ADDENDUM 01

Addendum to the drawings and specifications for:
Kendall County – Emergency Medical Services Station No. 3

EMERGENCY MEDICAL SERVICES STATION NO.3

10.06.23

project number: 22-41
date: 08.15.23
sheet number: **A2.4**
Beaty Palmer Architects, Inc. 110 Broadway, Suite 600 San Antonio, Texas 78205
Voice 210.212.8022
Fax 210.212.8018
www.beatypalmer.com

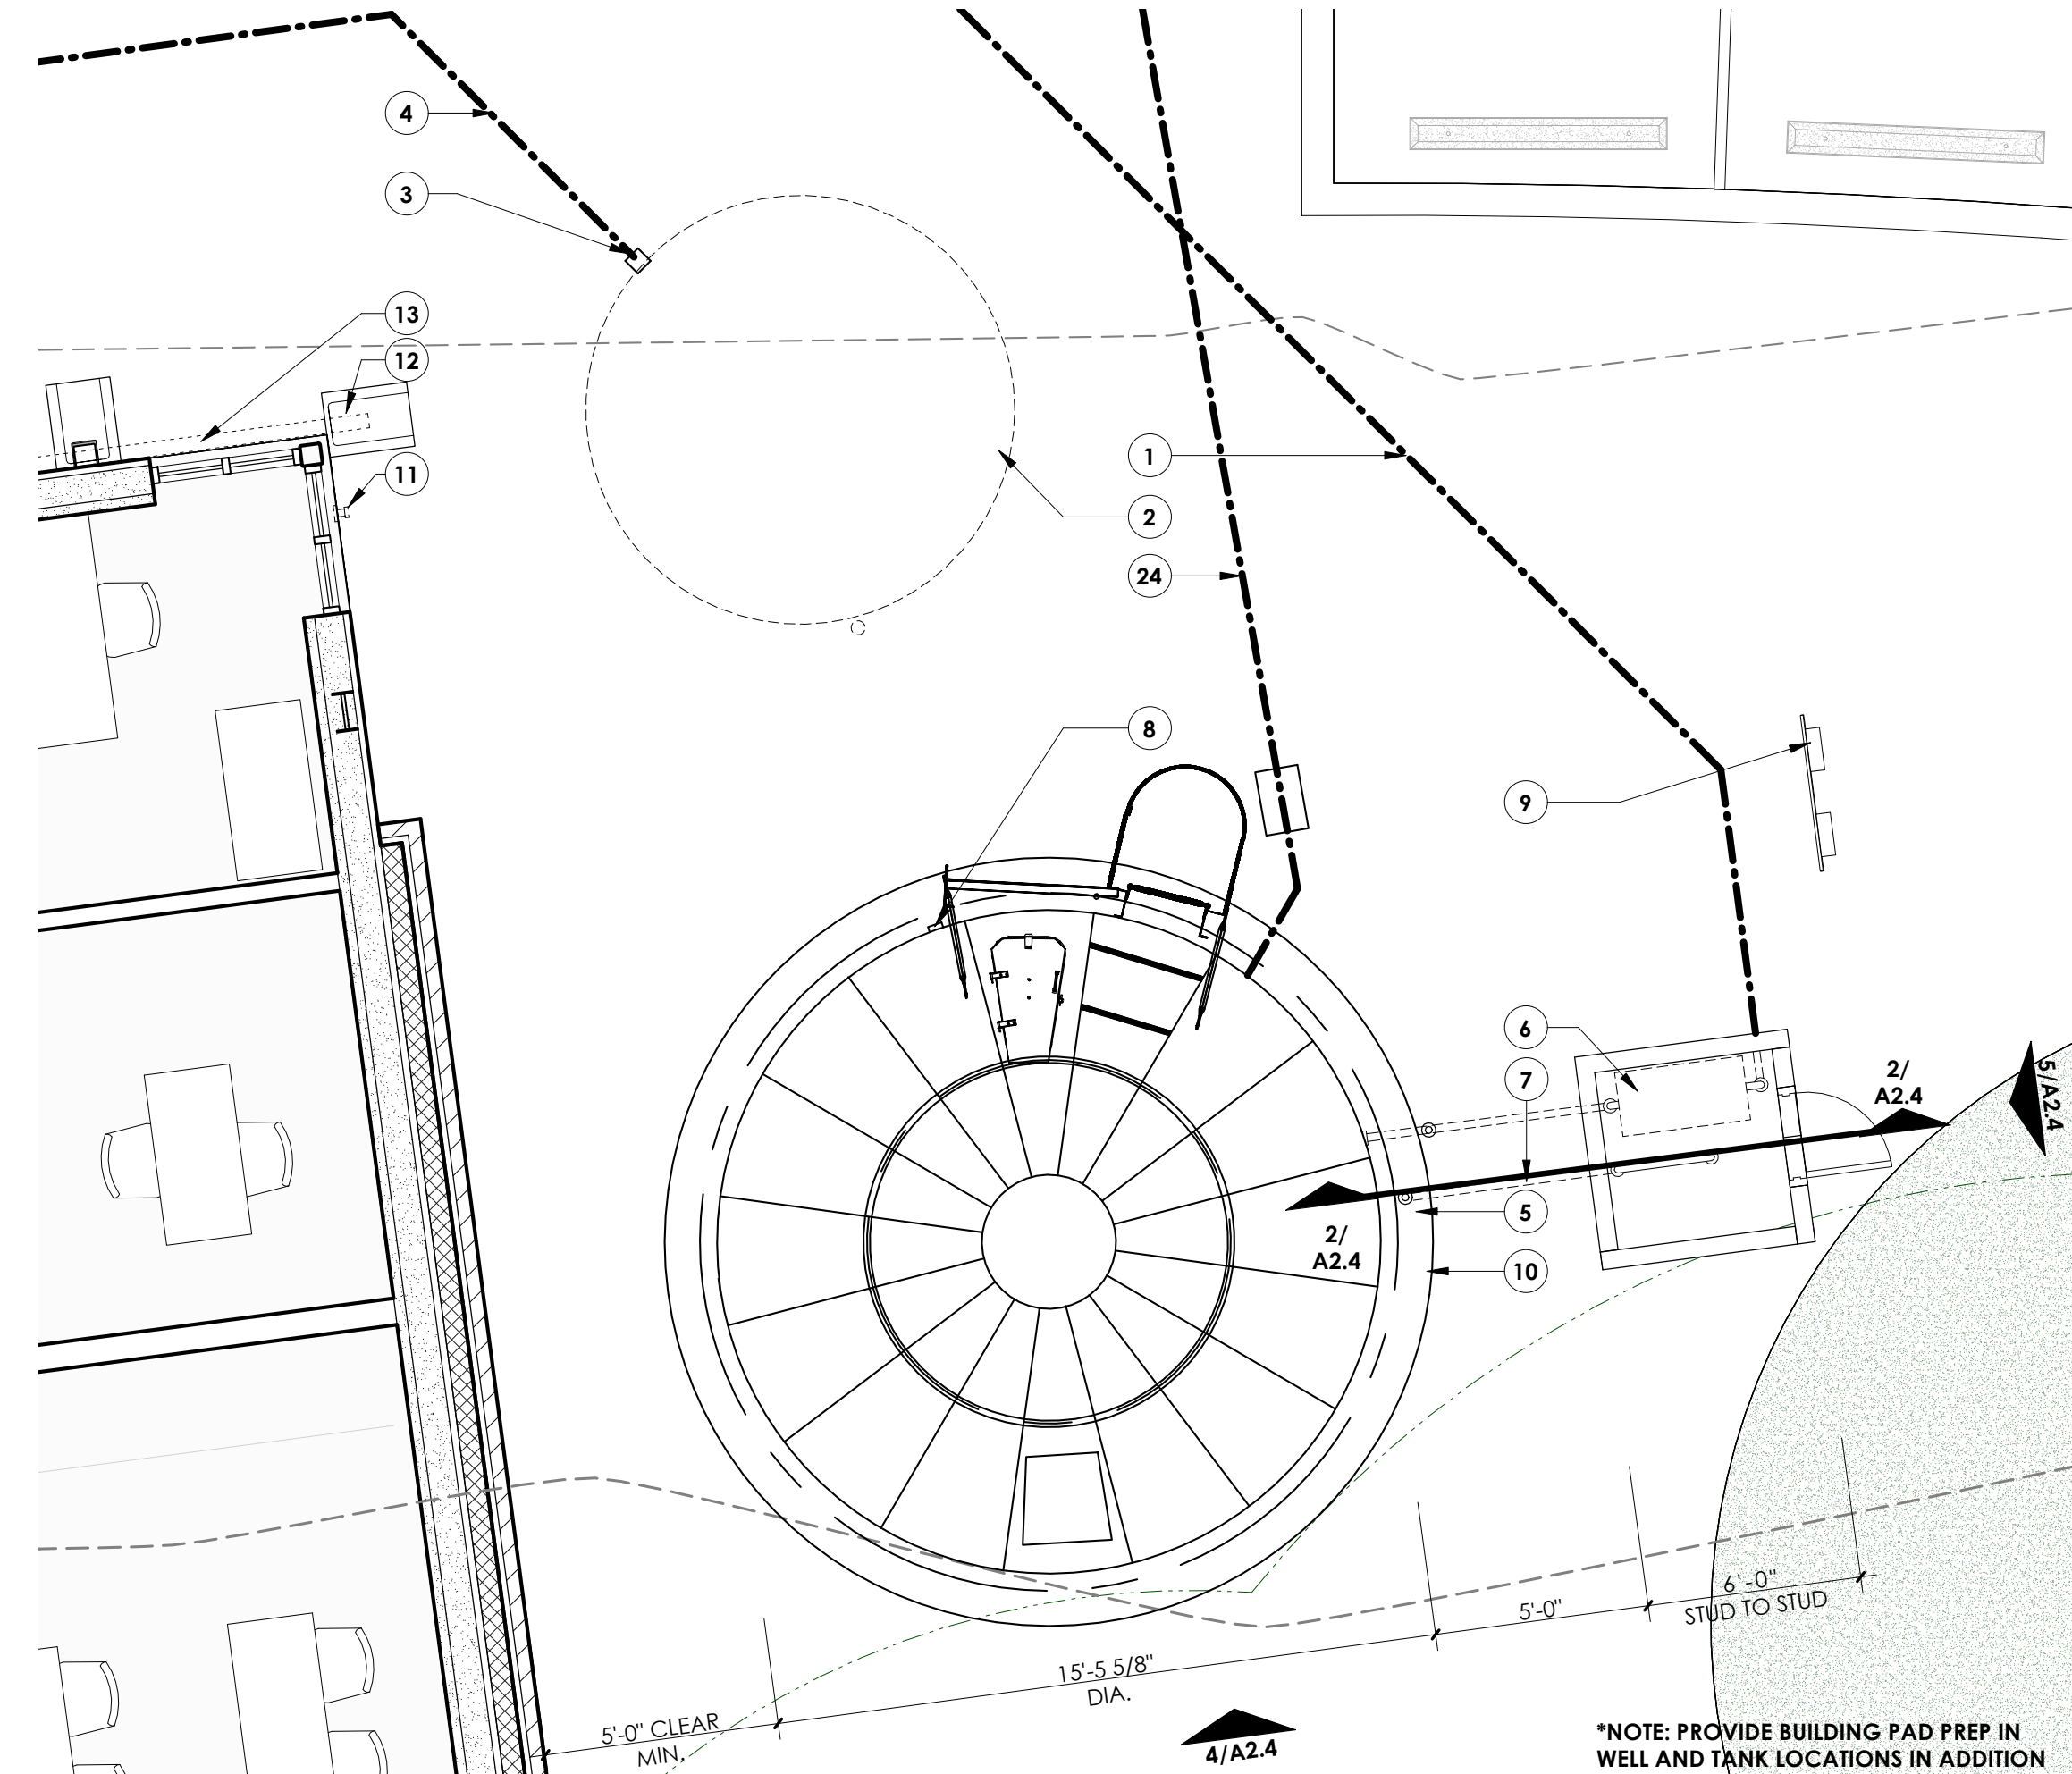
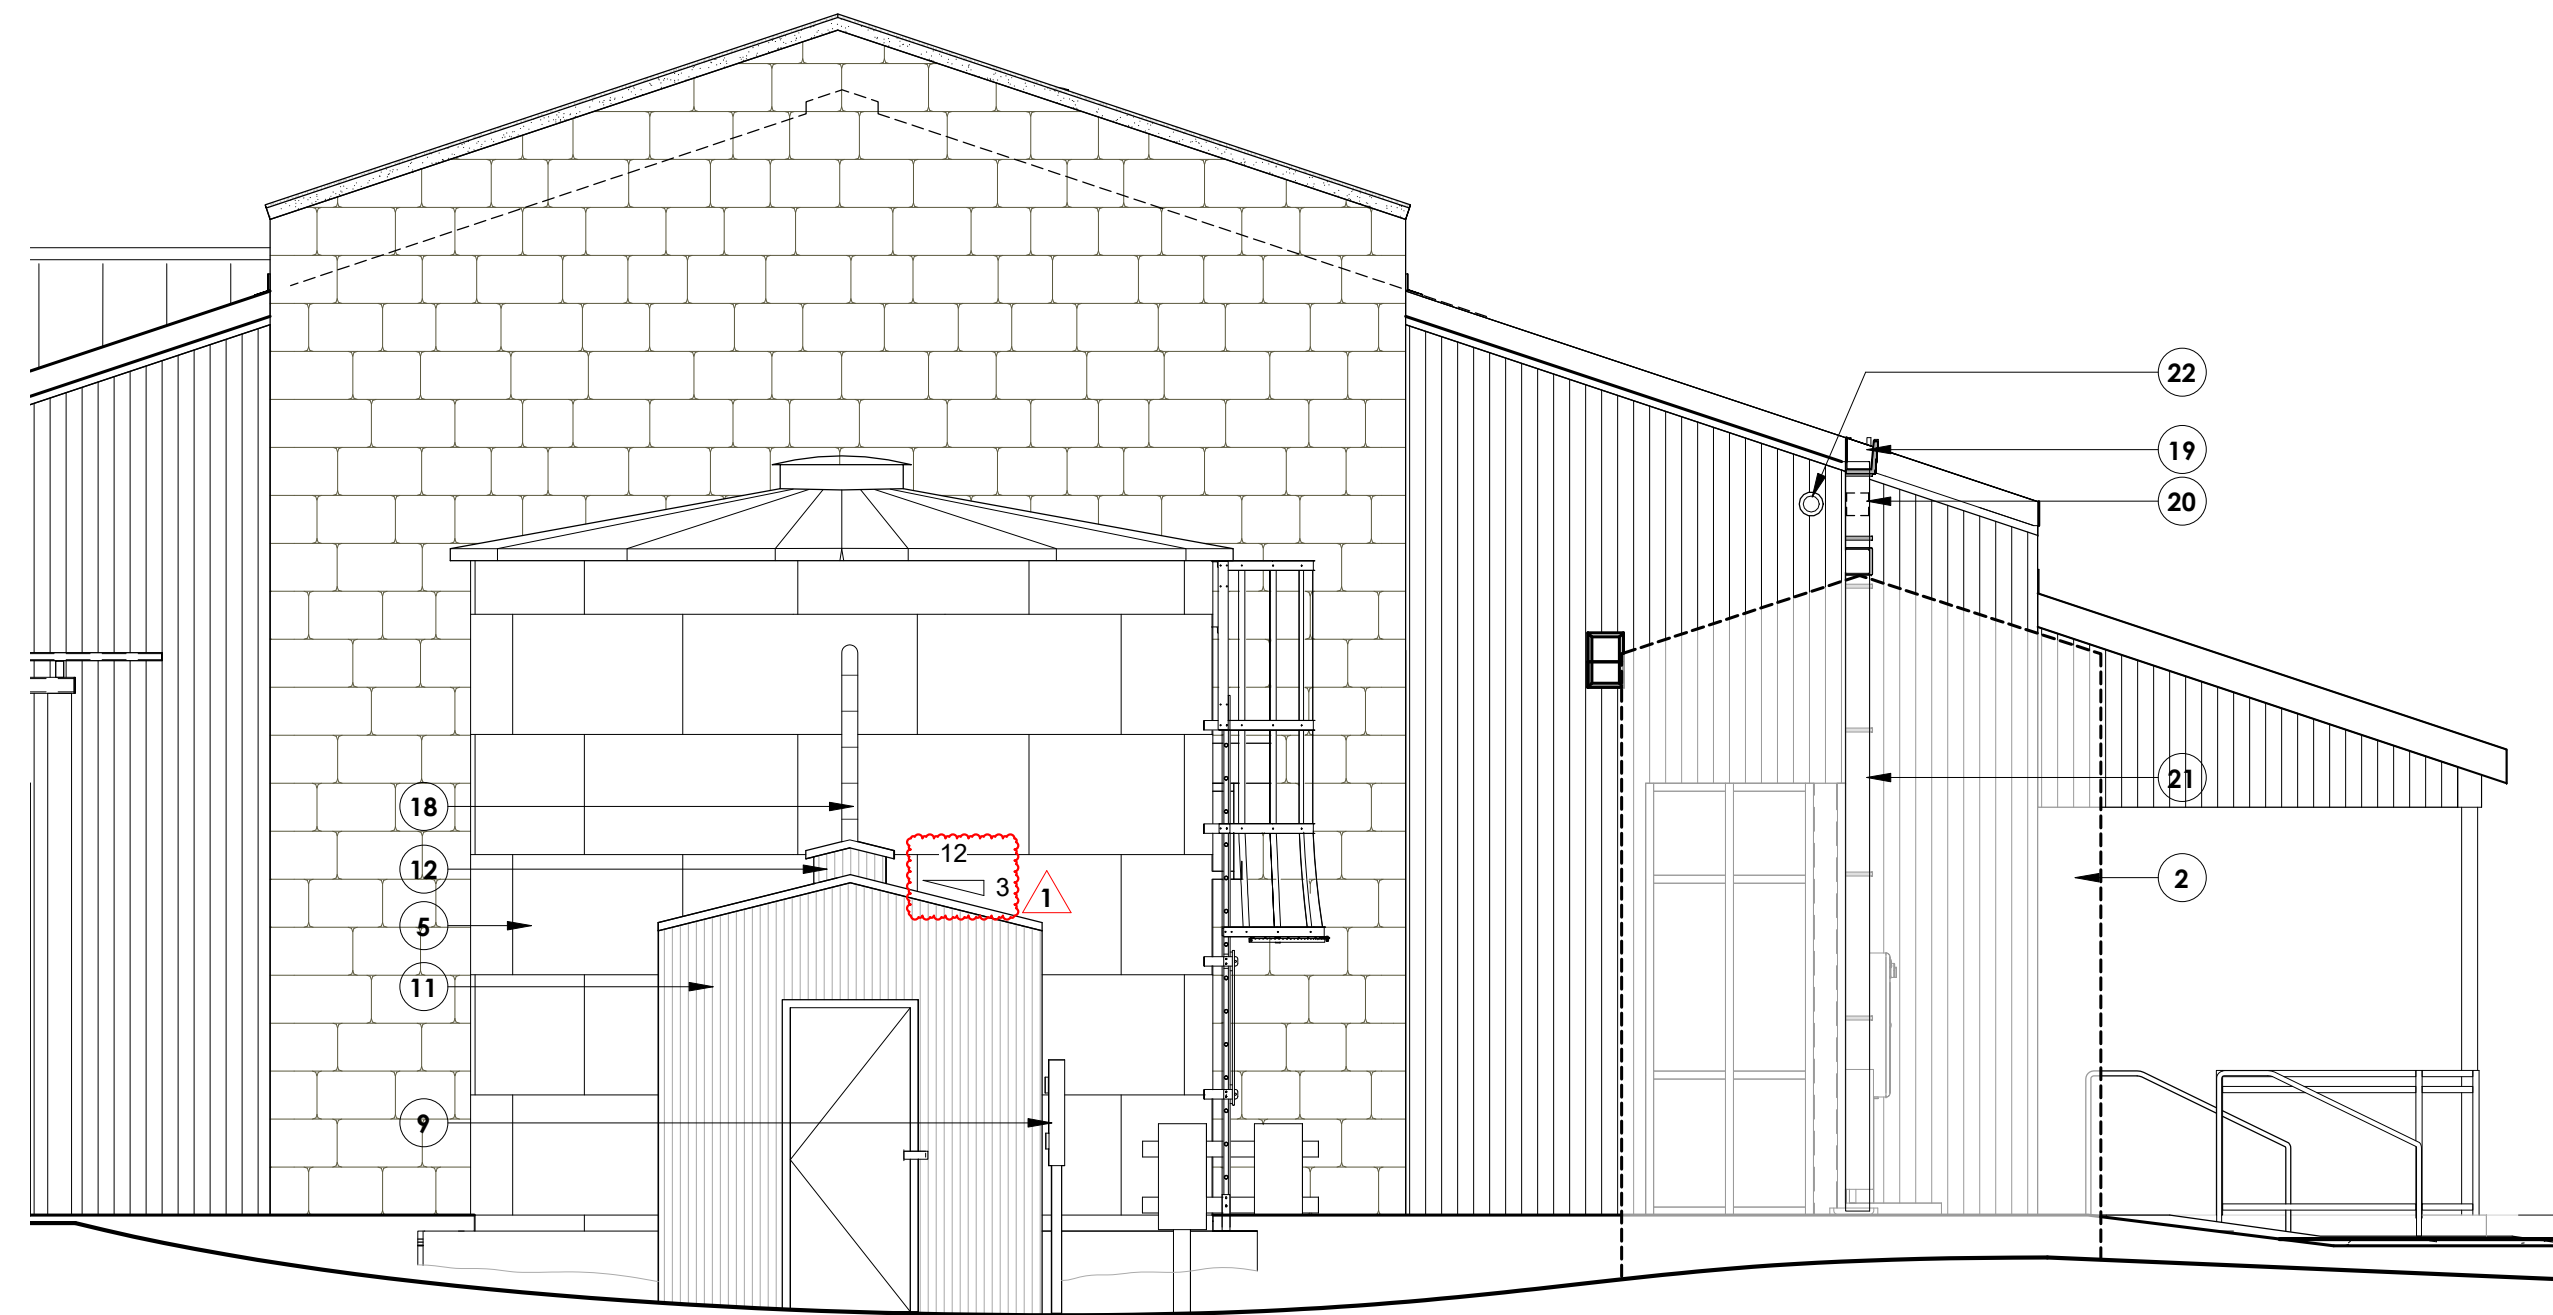
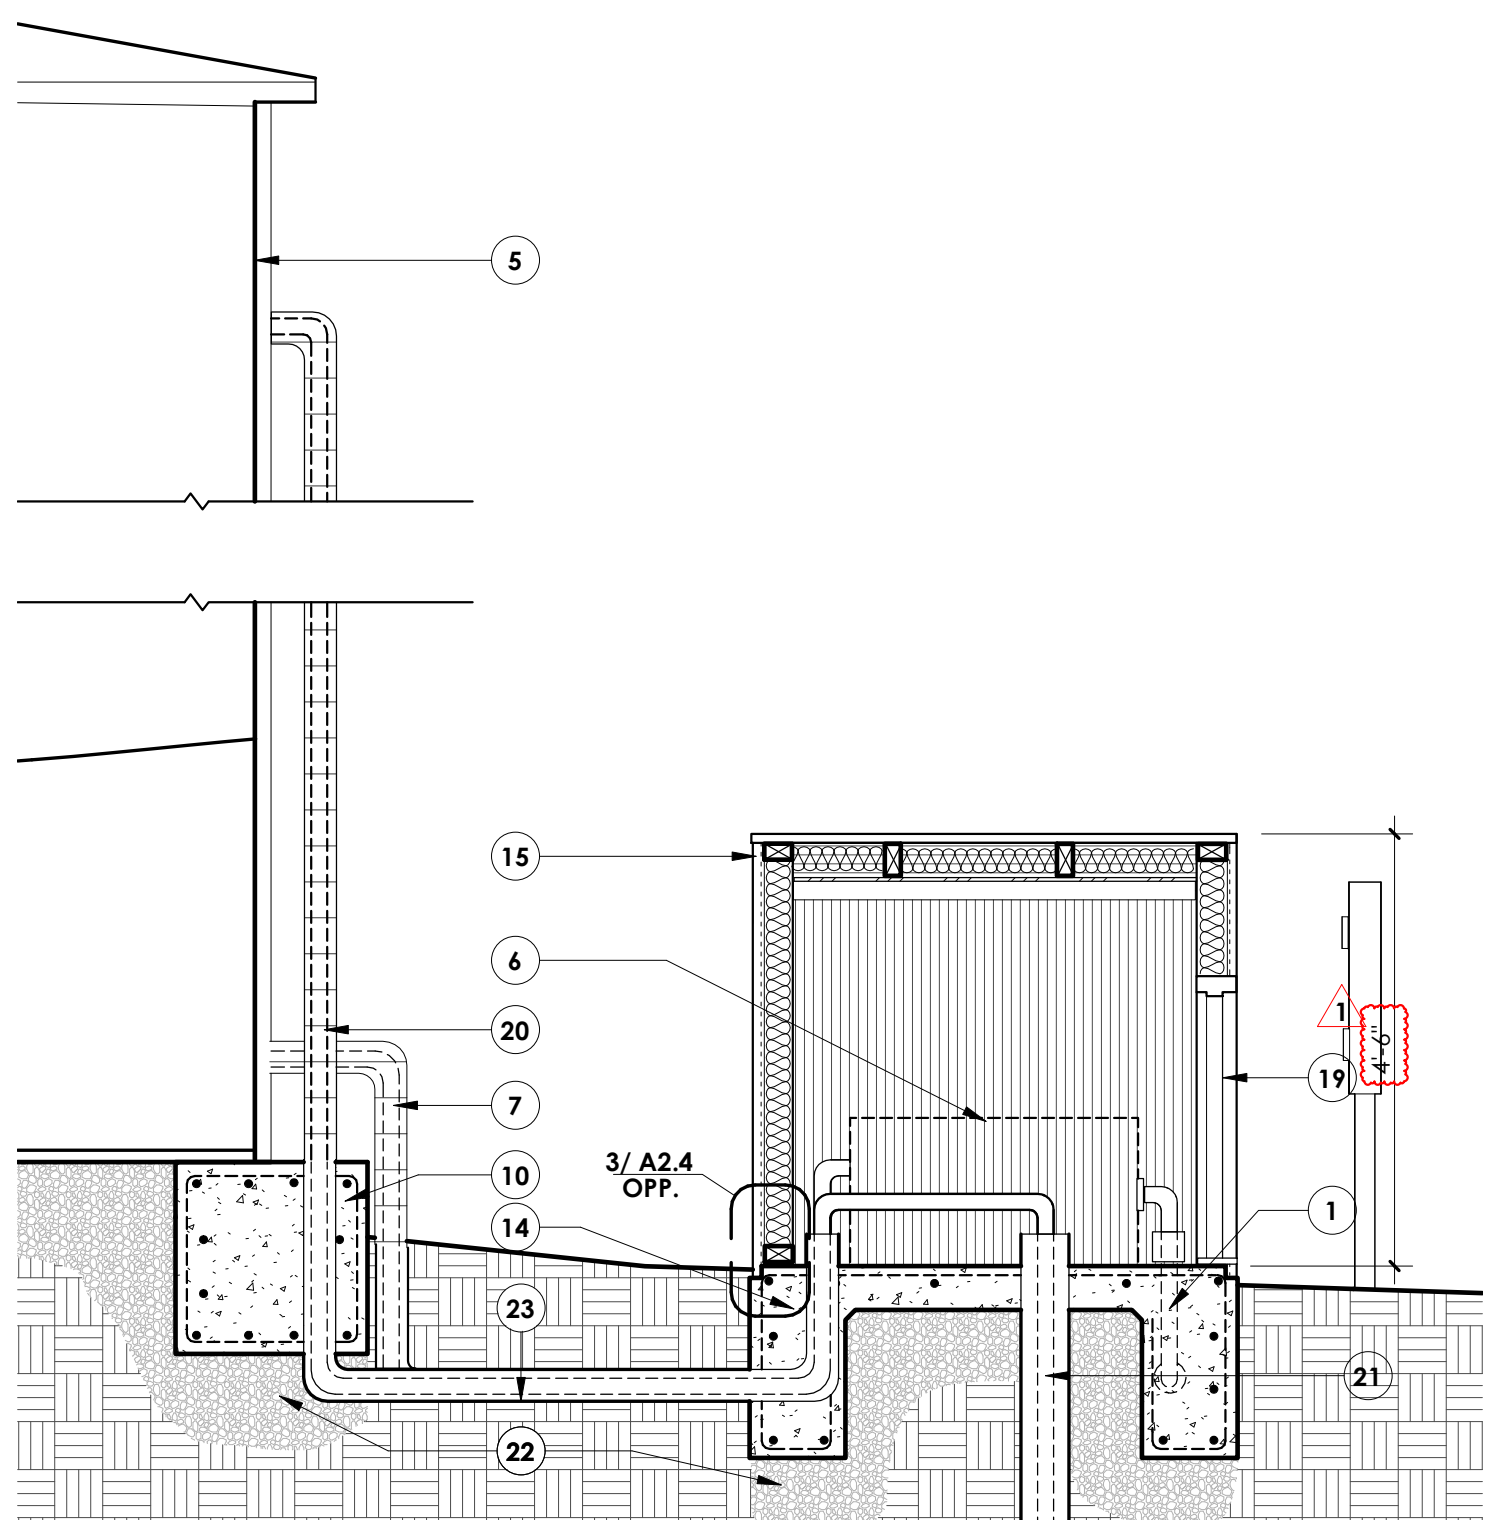
Item 1.10 – Updates Water Well Sheets A2.4 and A2.5

Dimensions on Dog House and Special Water Well Notes updates per water well questions and responses below.

Response to Question 3: *Refer to added dimensions on updated sheet A2.4 & A2.5 for clarification.*

Response: Provide 3 HP Domestic Water Booster Pump with 208 volt single phase power sized to provide 41 gpm at 60 to 70psi. Refer to updated sheets A2.4, A2.5, and E1.0

Response: Yes, provide and install a low water level alarm to be set at 40% capacity of the domestic water tank. Refer to updated sheets A2.4, A2.5,.

layout can be coordinated and confirmed during construction. Refer to updated keynote 23 & 17 on sheet A2.4 , A2.5.
